Groundwater contamination aspects of the proposed quarrying activity at Hatfield Aerodrome,

**Response to the Hertfordshire CC consultation on the Groundwater Management Plan (GWMP)
(Final v5) and SLR borehole data**

Date: 18th March, 2020

Client: Hatfield Town Council

Fig. 1a. Current groundwater flow in LMH aquifer (using actual site hydraulic head contours obtained from GWMP DRW 02). The convergent contours support that groundwater flowing through the Site will be extracted by the Bishop's Rise scavenger well.

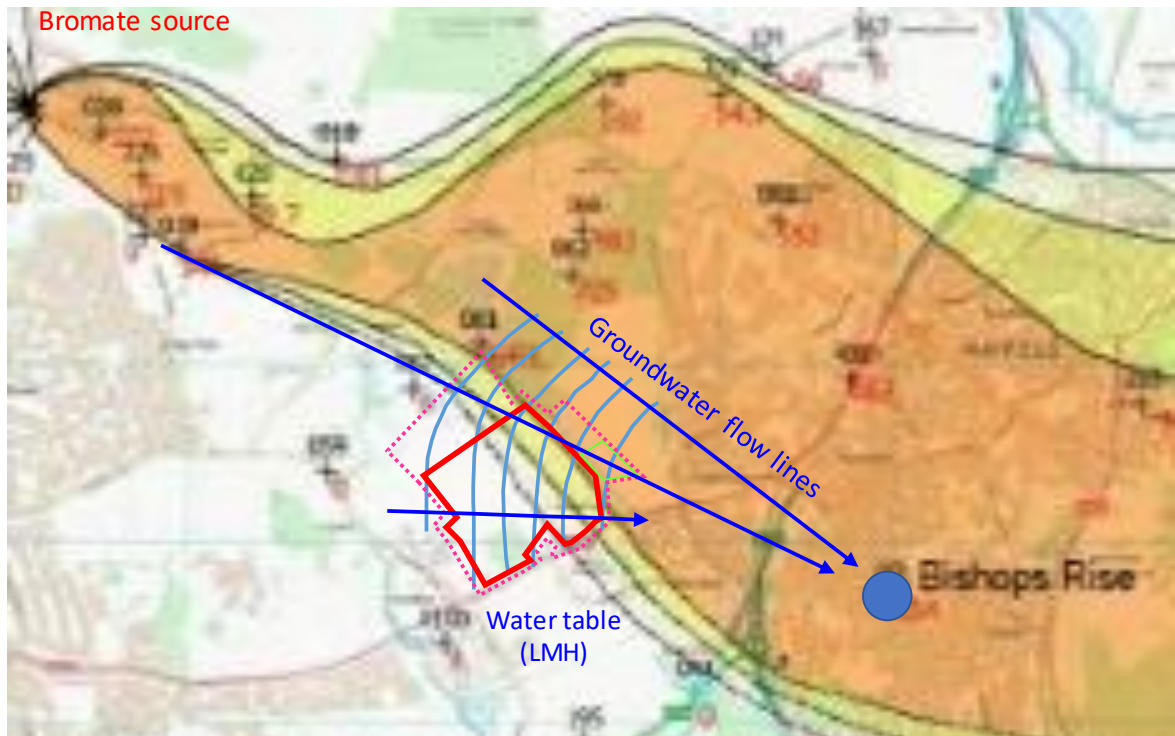
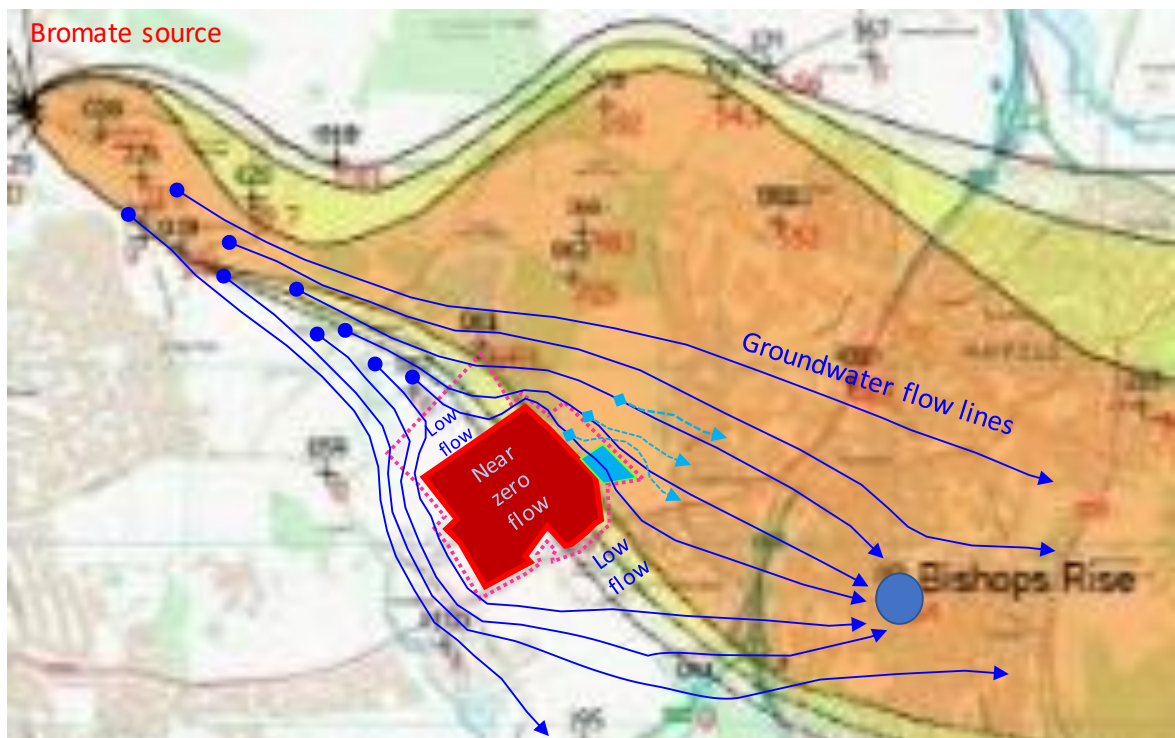
- iii. **any activities close to the plume must not interfere with the remediation of the bromate and bromide pollution."**
4. **Regarding failure to comply with EA Condition ii, "any activities close to the plume must not change the existing hydrogeological flow regime"** - Whilst the GWMP makes efforts to reduce risks of temporary flow regime change by attempting to limit extraction of groundwater from the LMH, what appears overlooked, and of much more significance, is the **permanent change in the existing groundwater flow regime (with associated nearby bromate/bromide plume consequences) that will arise from the wide-scale removal of very permeable sand-gravel Lower Mineral Horizon aquifer material below the boulder clay and its subsequent replacement with near 'impermeable' backfill "site won overburden and interburden material"** (GWMP, Section 2.2.3 (LMA meaning Lower Mineral Aquifer has been replaced by LMH aquifer here and elsewhere for ease of reading) (Also, described in Brett Response to Hatfield Road Quarry, Consultation Questions and Statements (21 August 2019): *"The LMH within all phases will be backfilled with site won clay forming a low permeability flow barrier ..."*). The net outcome of the proposed extraction of around 55% of the 8 million tonnes of sand/gravels by the development **is to replace some 4.4 million tonnes (~ cubic metres) of highly permeable sand-gravel LMH aquifer material over an area of ~ 500 m by 500 m that currently transmits significant groundwater flow, with a vast plug of aquitard, near**

impermeable, clay material; this will act as a “*low permeability flow barrier*” and fail to transmit barely any of the LMH aquifer flows continuing from upstream of the site – these flows will have to, forever post-development, divert around this vast near impermeable, permanent plug of aquitard. Ironically, the protective boulder clay aquitard has become the replacement aquifer, a very poor one at that. **The divergence in flow, and “existing hydrogeological flow regime” change constitutes a significant and permanent breach of EA condition ii, with knock-on breaching of EA Condition iii due to its influence on the nearby plume and consequent change in plume capture by the plume-remediation scavenger well.**

5. Expanding on the groundwater flow detail and breaching of EA Condition ii caused by aquifer excavation and backfill by “*site won overburden and interburden material*” - Impact of the backfill is briefly mentioned in the GWMP predicting “*As the filling proceeds and given the permeability of the LMH aquifer, it is expected that any resulting mounding of the groundwater surface created by the infilling process will be slight and short-lived and the groundwater equilibrium will quickly re-establish itself because of the hydraulic connection between the chalk and the LMH aquifer.*” (GWMP, Section 2.2.3). Some process aspects are valid, however the outcome indicated is not. **The impact of the considerable volume of low permeability material used to fill the former aquifer void on the hydrogeological flow regime is long-term, permanent and significant.** Examination of the current groundwater flow field contouring in the GWMP (DWG No. 02 (page 32)) and reproduced in Fig. 1a below indicates a currently **unhindered** (even contoured) groundwater flow gradient through the site’s sand/gravel LMH aquifer. Moreover, added groundwater flow direction arrows (approx.. ~ perpendicular to contours) confirm site groundwater currently convergent on the Bishop’s Rise scavenger well. **The data strongly supports all current LMH aquifer groundwater flow across the site ultimately reaches and is extracted by the scavenger well. Hence, any perturbation of site flows must interfere with the extracted water scavenged by the well. The permanent insertion of roughly 4.4 million tonnes (~ cubic metres) of low permeability clay backfill across the site into the LMH has to cause considerable changes to the existing LMH hydrogeological flow regime; flow will simply not be able to easily migrate cross site post backfill within the LMH.** Whilst 3-D numerical flow modelling would be required to predict this accurately, **reasonable conceptualisation illustrated in Fig. 1b is that the majority of diverted LMH groundwater flow will laterally flow around the site’s low permeability aquitard plug, moving more easily horizontally into the wider LMH aquifer** (flow may occur through ~20% of a porous gravel unit compared to just ~2% of the fractured chalk, recognising relative transmissivities are also influential). **Lateral spreading of groundwater will also be enhanced by the flow-restricting, capping boulder clay unit remaining beyond the Site boundary.** Whilst it could be argued some limited flow may still traverse site in the deep thin layer of LMH gravels not extracted, flows may be partly restricted due to partial plugging by **wash out of the backfilled over/interburden fine clay particles accumulating there.** Further wash out of backfill fine sediments and groundwater transport especially into wider chalk fissures, could also lead to **‘Suspended sediment’ problems at the Scavenger well** and reduce its efficiency. A complex 3-D integrated numerical model of both the LMH and Chalk would be required to predict the flow diversion created and the alteration of flowlines of groundwater arriving at the scavenger well. **Certainly though, the EA Condition ii) any activities close to the plume (it is, see following point(s)) must not change the existing hydrogeological flow regime, cannot be met.**

Fig. 1b. Conceptualised LMH aquifer groundwater flow being deflected around low permeability clay backfill of quarried LMH void with increased potential for flowlines to now evade capture by the Bishop's Rise scavenger well. Deflection (light blue pathlines) is also induced by temporary infiltration lagoon discharges to LMH. Distortion of flowlines will be influenced also by distribution of the gravels to some degree (not shown). The conceptualisation illustrates the permanent breaching of EA Condition ii.

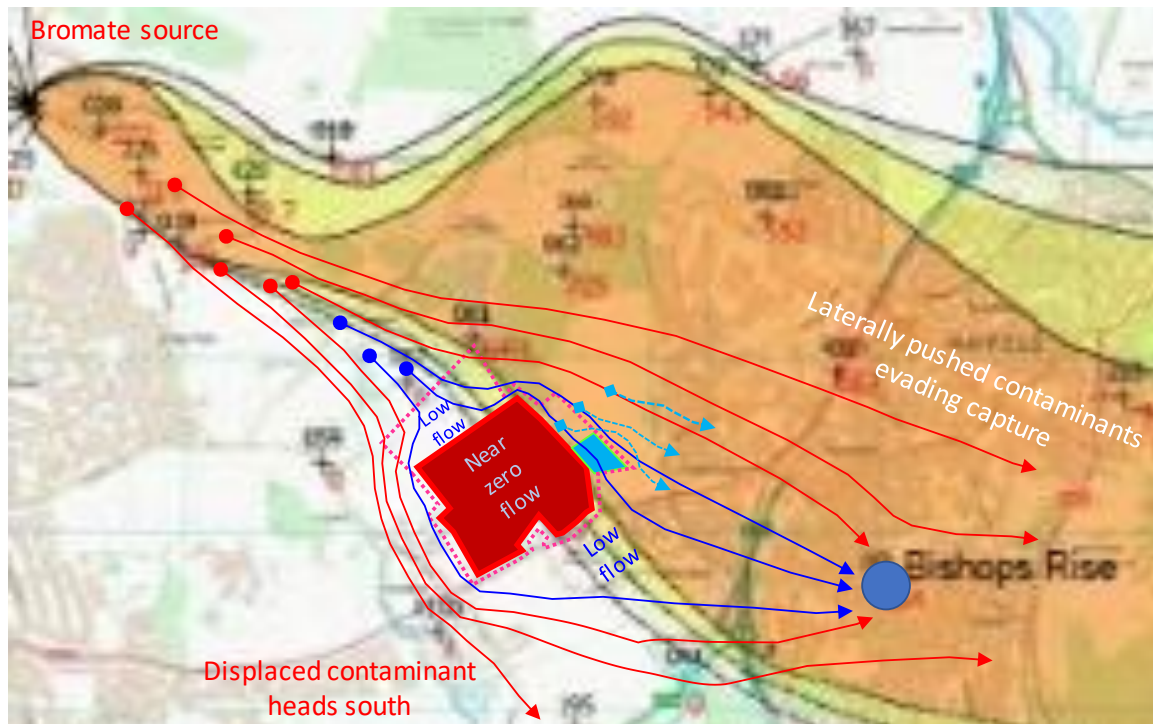
- v. The occurrences of high bromate plume concentrations very close to site are an important evidence supporting the significance of the above Fig. 2 conceptualised influence of the low permeability backfill of the LMH void and 'pushing' away of the plume from the Site. **These concentrations demonstrate conclusively there is a bromate plume very close to Site to push away that will decrease the capture potential of the scavenger well and hence the failure to comply with EA Condition iii.** Whilst these near-to-site plume concentrations would still likely be captured by the scavenging well, **it is the more laterally displaced plume core, higher concentrations, slightly further away from Site that may ultimately evade scavenger well capture leading to a decrease in scavenger well remedial performance.** Combining both Fig. 2 conceptualisation of the diverted flow around the low permeability plug inserted in the LMH aquifer with the Fig. 3 conceptualisation of increased bromate in groundwater on the quarry site **with increased scavenger well pumping rates may produce quite complex outcomes** that really require numerical modelling to assess. A key concern though at high scavenger rates is that the higher concentrations drawn down to the south side of site could deflect further southwards towards Tytenhanger and Roestock abstractions.

increasing risks of the plume core being pushed further away eastwards from the scavenger well and evading capture by the well (i.e., the same problem outlined above in Fig. 2).

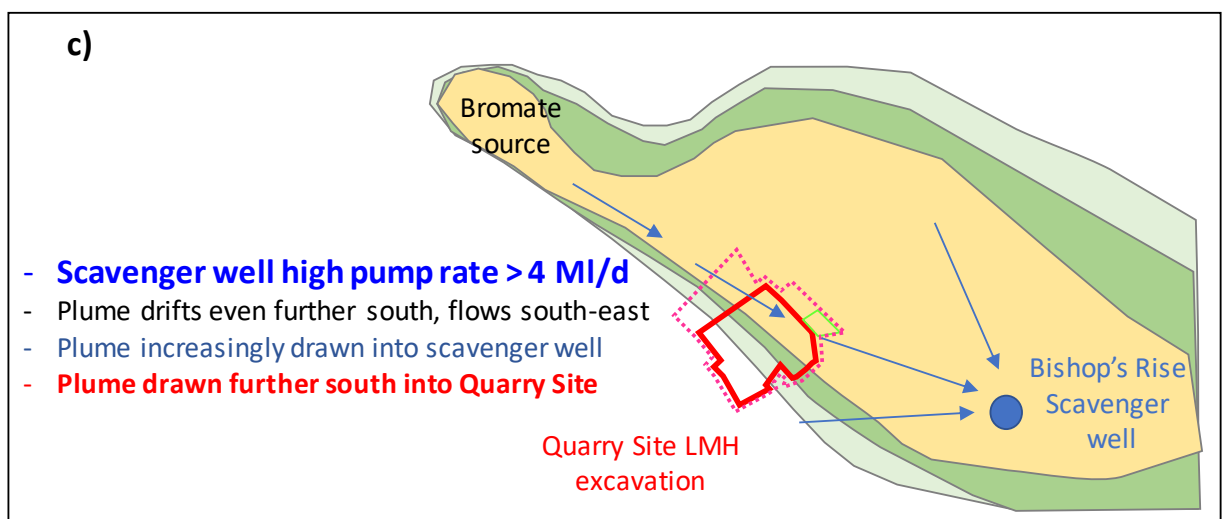
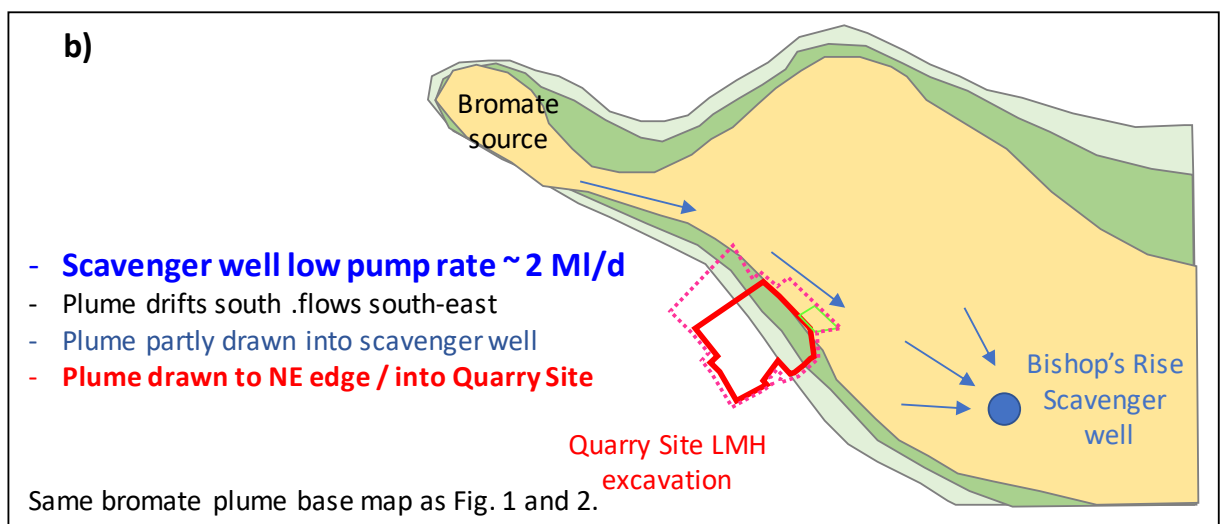
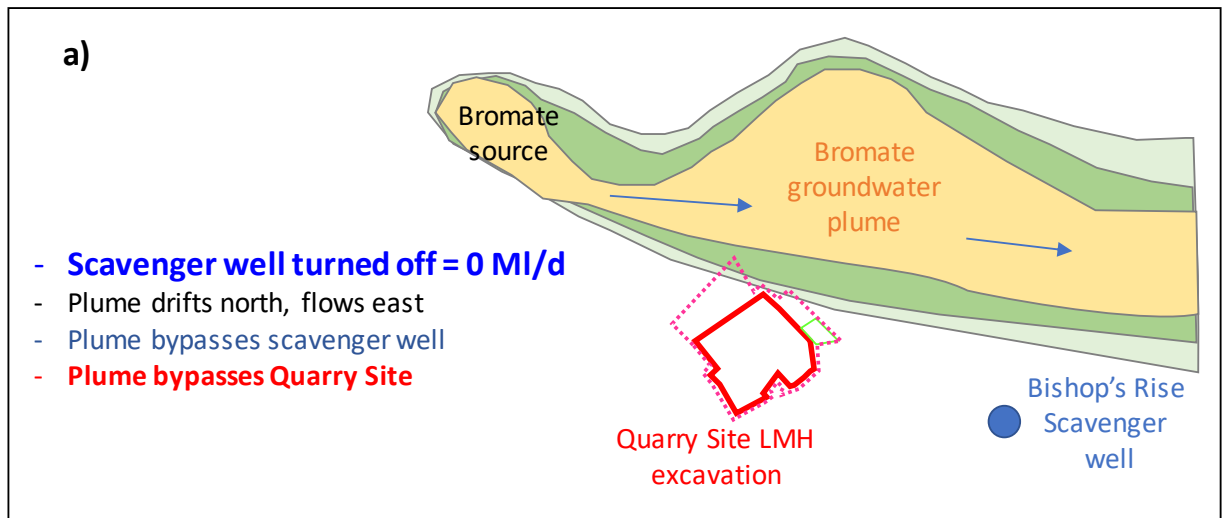
- i. **Occurrence of bromate groundwater contamination in the LMH and chalk underlying the Quarry Site is significantly controlled by the extraction rates of the Bishop's Rise scavenger well – this is conceptualised in Fig. 3. Fig. 3a conceptualises if the Bishop's Rise scavenger well is not operating** then the bromate plume would be expected to largely bypass both the scavenger well and the quarry Site, the latter facilitating EA Condition i to be more likely met (subject to draw in of the plume by the quarry groundwater abstraction). The plume pose threats to other public water supply wells, notably Essenden. **Fig. 3b conceptualises increased scavenger well pumping rates to say 2 MI/d, quite low scavenger rates that are comparable to recent actual rates** (rates that have been lower than optimal due to effluent discharge constraints (sewer pipe partial blocking)), draws the plume southwards, capturing part of the plume in the scavenger well, but also causing the bromate plume to begin to encroach into LMH and chalk groundwater on the eastern side of Site. This would account for recent observations of a bromate plume very close to the north-east corner of the quarry Site. **Fig. 3c conceptualises yet further increased pumping to around 4 – 5 MI/d more optimal plume remediation rates**, that have been recently implemented at Bishop's Rise (following rectification of the effluent discharge constraint above) would cause the plume to be drawn yet further south giving an increased bromate mass abstraction (i.e. improved remediation), but also increased draw of the bromate/bromide plume through the quarry Site groundwater. **The conceptualisation indicates that a significant and likely overwhelming control of bromate groundwater contamination occurrence in quarry Site groundwater is the pumping rate of the Bishop's Rise scavenger well. Higher abstraction rates of 4 – 5 MI/d preferred for more optimal remediation (plume capture and protection of other supply wells) will lead to greater bromate plume migration into the quarry site LMH aquifer gravels and increased risk of breaching EA Condition i. Hence the viability of meeting EA Condition i is not controlled by the Site developer primarily, but rather the operator of the Bishop's Rise scavenger well, i.e. Affinity Water** (potentially influenced by other stakeholders, e.g. the EA, local community who may wish to see optimal plume remediation). **This sensitivity of the viability of meeting EA Condition i upon a third party's activity is a direct consequence of locating the quarry close to the high concentration gradient fringe of the bromate plume and directly in between the main bromate source area and the single scavenger well remediating the plume. The viability of extraction of the LMH gravel resource hence appears dependent upon the operation of the Bishop's Rise scavenger well at rates that may be sub-optimal to the remediation of the bromate plume. Development of the quarry and meeting of EA Condition i would hence require the scavenger well pumping rates to be sub-optimal for remediation – this does not seem appropriate - it constitutes interference with the remediation of the bromate and bromide pollution (i.e. breaching of EA Condition iii).** Most of the points that follow can be understood within the above conceptualisation.

- ii. Regarding bromate groundwater contamination, the EA indicate bromate concentrations of concern are $\geq 2 \mu\text{g/l}$ (0.002 mg/l), consistent with application elsewhere. It appears at some time seven boreholes at the Site perimeter, have displayed bromate contamination with six above the $2 \mu\text{g/l}$ limit. This frequency of discovery points to bromate occurrence on site remaining a viable issue of concern, particularly as the **monitoring of the LMH appears sparse in the perimeter area most likely to be contaminated (the north-east to east side of Site) and extremely sparse on Site in the LMH areas to be quarried.** Regarding very near-to-Site monitoring wells to the immediate east, bromate is very elevated in the LMH at 14, 92 and $233 \mu\text{g/l}$ and slightly further away laterally at $563 \mu\text{g/l}$ (Borehole 12) in the plume core, **all very significantly above the EA threshold.** The current low, but above-limit, bromate concentrations on the site perimeter (and potentially on site – little data) but with the bromate plume very close by is attributed to quite low scavenger rates of Bishop's Rise in recent years along the lines of the Fig. 3b conceptual model. **The concern is that with the recent increase in Bishop's Rise pumping rates back to achieve more optimal plume remediation conditions will lead to southward drift of the plume and increases in bromate on site as the site scenario gradually evolves (will not be instantaneous) to a Fig. 3c conceptualisation and increased risk of breaching EA Condition i.**
